SERVICE BULLETIN

M-1085

Safety Recall Code 098

FUEL TANK VENT LINE CONNECTOR

Figure 1. Obtain Large Paper Clip and Drill Bit

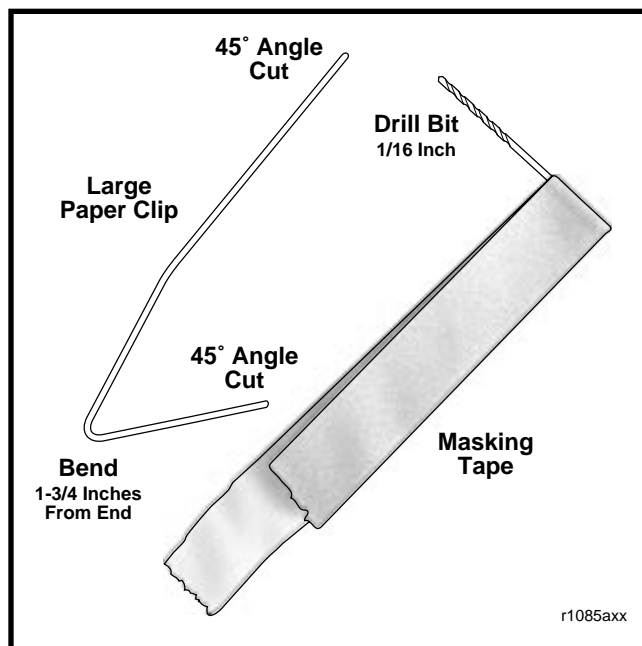
1. Obtain a large paper clip (approximately 0.060 inch in diameter) and proceed as follows:
 - a. Straighten the paper clip.
 - b. Using a side cutters, snip off each end at a 45° angle, so that a sharp point exists on both sides.
 - c. Bend the paper clip 1-3/4 inches from one end. See Figure 1.
2. Obtain a 1/16 inch drill bit. Apply masking tape to the bit as shown in Figure 1. The masking tape will prevent the bit from dropping into the swingarm tube on Softail models.
3. See FINAL INSTRUCTIONS below.

Figure 2. Unplug Connector (Dyna Models Shown)

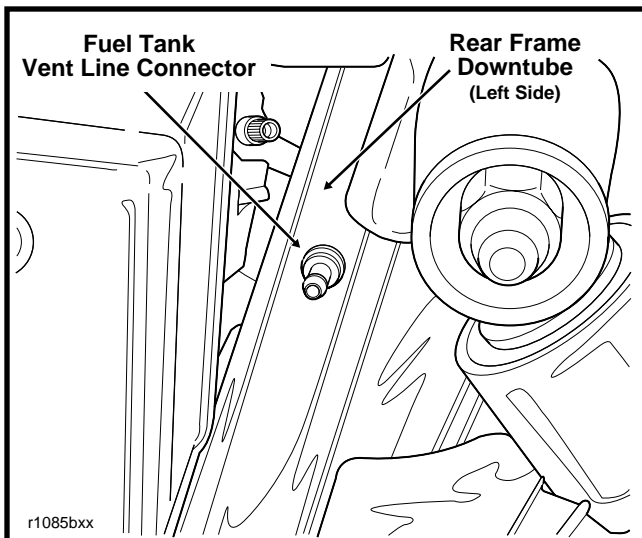
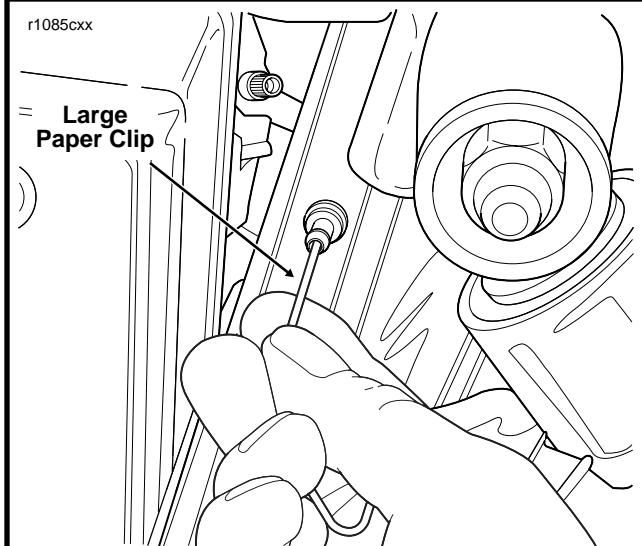
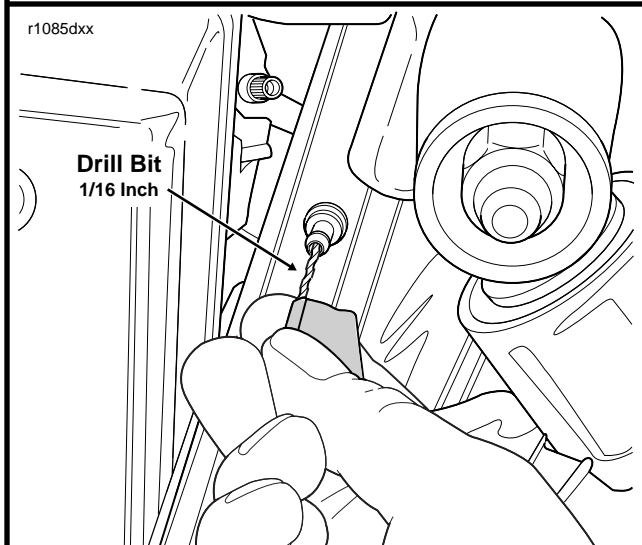
The recall service involves opening the channel in the fuel tank vent line connector on all potentially affected vehicles. During manufacture of the connector, plastic flashing may have formed to close the channel. While the channel may be obstructed on only 8 percent of all potentially affected vehicles, the recall service must be performed on all vehicles to ensure that the condition does not exist.

1. Locate Vent Line Connector and Remove Hose.

2. Punch Hole in Flashing Using Point of Paper Clip.

3. Ream Hole in Flashing Using 1/16 Inch Drill Bit.

2. Standing on left side of vehicle, locate fuel tank vent line connector in rear frame downtube (directly above passenger foot peg).
3. Remove rubber elbow fitting from connector. See upper frame of Figure 2.
4. Insert **long** end of paper clip into the connector and push with enough force to punch a hole through the plastic flashing. Run the paper clip back and forth several times to enlarge the hole. See center frame of Figure 2.
5. Insert a 1/16 inch drill bit into the end of the connector and through the hole in the flashing. Run the drill bit back and forth as necessary to clear away the flashing and ensure that the channel is open. See lower frame of Figure 2.
6. Install rubber elbow fitting onto vent line connector.
7. See CREDIT PROCEDURE on page 3.
